Office Action Summary

10/537,828

DETAILED ACTION

F I G. 1

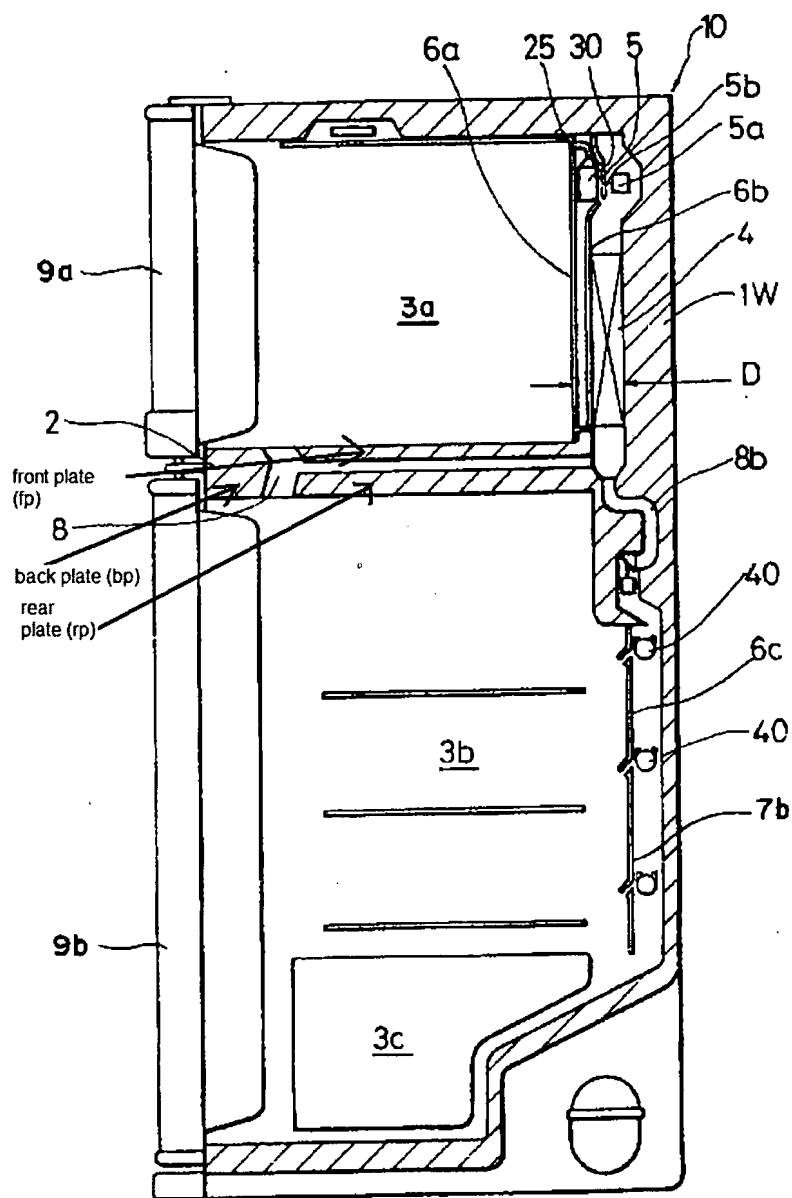
In regard to claims 1 and 16, Lee et al. teach a refrigerator (10) (see Fig. 1) comprising a freezing chamber (3a) (see Fig. 1 and col 2 lines 66-67 and col 3 lines 1-3), a refrigerating chamber (3b) at a side of the freezing chamber (3a) (see Fig. 1), a barrier (2) between the freezing chamber (3a) and the refrigerating chamber (3b) (see Fig. 1 and col 2 lines 66-67 and col 3 lines 1-3), the barrier (2) having a freezing chamber cold air passage (passage between 8 and 8b) formed therein (col 1 lines 28-31).

Lee et al. also teach a partition plate (6b) for compartmentalizing a freezing chamber cold air passage (passage between 8 and 8b) in rear of the freezing chamber (3a) where an evaporator (4) is positioned (see Fig. 1 and col 1 lines 20-21 and 24-26), the evaporator (4) provided at an angle along the freezing chamber cold air passage (passage between 8 and 8b) and a refrigerating chamber cold air passage (7b) (see Fig. 1, the evaporator is at a right angle to the length of the freezing chamber cold air passage (between 8 and 8b) and is perpendicular to a portion of the refrigerating chamber cold air passage 7b), a partition wall (rp) between the freezing chamber cold air passage (passage between 8 and 8b) and the refrigerating chamber cold air passage (7b) (see annotated Fig. 1 below).

Lee et al. also teach a fan (5) mounted over the freezing chamber cold air passage (passage between 8 and 8b) and the refrigerating chamber cold air

passage (7b) (see Fig. 1 and col 1 lines 22-23) for discharging cold air flowing through respective cold air passages (7b, 8) to the freezing chamber (3a) and the refrigerating chamber (3b), respectively (see Fig. 1). The fan (5) forces air into the freezing chamber (3a) and refrigerating chamber (3b) using the partition plate (6b) to direct the airflow of the coming from the fan (5). It is presumed that the fan (5) is mounted over both passages and there is only one fan in the system, not two separate fans as the language of the claim indicates "a fan" in the singular.

In regard to claims 2 and 18, Lee et al. teach the refrigerator (10) wherein the evaporator (4) includes a first part exposed (exposed through vent 6a – see Fig. 1) to the freezing chamber cold air passage (passage between 8 and 8b) (see Fig. 1) and a second part (8b) exposed to the refrigerating chamber cold air passage (7b) (see Fig. 1). The face of the evaporator adjacent to the vent 6a is exposed to the chamber cold air passage via the duct 8. The second part (8b) tubing extends from the bottom side of the evaporator (4) to enter the refrigerating chamber cold air passage (7b).

In regard to claims 3 and 19, Lee et al. teach the refrigerator (10) wherein the first part (6a) is larger than the second part (8b) (see Fig. 1). The surface area of the first part (6a) facing the freezing compartment (3a) is larger than the surface area of the second part (8b) facing the opening to the refrigerating compartment (3b) (see Fig. 1).

In regard to claims 4 and 20, Lee et al. teach the refrigerator (10) wherein an outer surface of the first part (6a) and the second part (8b) is separated by the

partition wall (rp) for preventing the cold air flowing through the respective parts from mixing with each other (see Fig. 1).

The In regard to claims 5 and 21, Lee et al. teach the refrigerator (10) wherein the partition plate (rp) includes a front plate (fp) and a back plate (bp) to form a

cold air passage (see passage between fp and bp connected between passage 8) between the plates (fp, bp) (see annotated Fig. 1 above).

In regard to claims 6 and 22, Lee et al. teach the refrigerator (10) wherein the front plate (fp) has a plurality of cold air discharge openings (opening at 8 and opening at 8b) formed therein (see annotated Fig. 1 above). The front plate has an opening to let air exchange between the refrigerating chamber (3b) and freezing chamber (3a) via opening 8. There is a second opening above 8b to let air exchange with the fan and evaporator (4) as seen in annotated Fig. 1 above.

In regard to claims 7 and 23, Lee et al. teach the refrigerator (10) wherein the back plate (bp) has an opening in an upper part thereof (into 8b) and the fan (5) is provided adjacent to the openings (8, 8b) (see Fig. 1). The fan (5) is adjacent via the evaporator (4) (see annotated Fig. 1 above).

In regard to claims 8 and 24, Lee et al. teach the refrigerator (10) wherein the partition plate (1w) has openings (8, 8b) in a lower part thereof to form cold air suction openings (see annotated Fig. 1 above). The front plate has an opening to let air exchange between the refrigerating chamber (3b) and freezing chamber (3a) via opening 8. There is a second opening above 8b to let air exchange with the fan and evaporator (4) as seen in annotated Fig. 1 above.

In regard to claims 14 and 28, Lee et al. teach the refrigerator (10) wherein the barrier (2) has cold air suction openings (8 – entering into freezing chamber 3a and a second entering into refrigerating chamber 3b) in a lower part of a

refrigerating chamber (3b) side thereof in communication with the refrigerating chamber cold air passage (7b) (see Fig. 1).

In regard to claim 17, Lee et al. teach the refrigerator (10) wherein the freezing chamber cold air passage (between 8 and 8b) and the refrigerating chamber cold air passage (7b) are in communication with each other (see Fig. 1) at one sides thereof and a damper (6c) is provided in a part of the communication is made (see Fig. 1 and col 1 lines 27-29). The freezing cold air passage and refrigerating chamber cold air passage are in thermal communication with each other via duct 8b and through the interior of the refrigerating chamber (3b). Wall (6c) acts as a damper in addition to partition plate (6b) (see Fig. 1).
